Inspection of Automatic Sprinkler System

CW1 International Automotive
Components East London Industrial
Development Zone

UNC8478

Photo 14

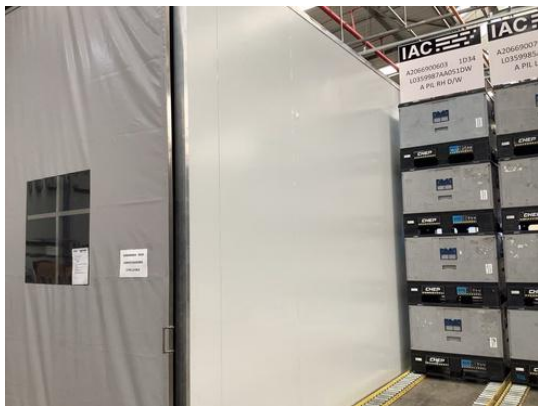
Portion of premises sprinkler protected with communicating sections that are not.

Partial protection can lead to a fire originating in the protected area radiating heat into the unprotected portion of the premises and starting secondary fires. The heat from these fires radiates or spreads back into the protected area causing excessive sprinkler operation.

Conversely, a fire originating in the unprotected portion will radiate heat or spread into the protected portion rapidly causing unnecessary sprinkler operation and overwhelming the sprinkler system installed.

New cold room
